PRODUCT BULLETIN

Product(s):	Fabius GS
Bulletin Number:	160
Release Date:	November 25, 2003
Pages:	2

Subject: Fabius GS COSY breathing system change

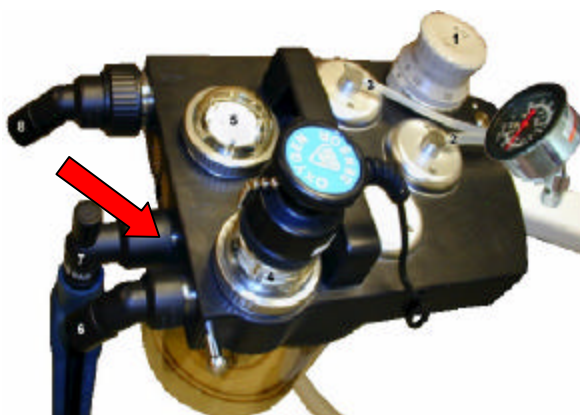
Effective immediately, all new production Fabius GS systems are being shipped with a COSY that is compatible with the CLIC absorber system.

The COSY change is a resolution of the compatibility issue with the CLIC absorber system. As a result of this change, the part number for the COSY has changed.

Old COSY

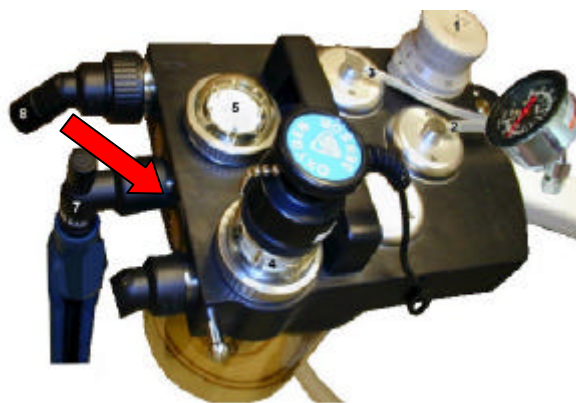
With the new COSY, the bag location has moved slightly.

As a result of the bag location change, the new COSY will require a different bag arm mount.

Please note that the old COSY is only compatible with the old bag arm mount, and the new COSY is only compatible with the new bag arm mount.

Swivel Bag Arm Part # (new COSY only)	4118380	\$ 450
--	----------------	---------------
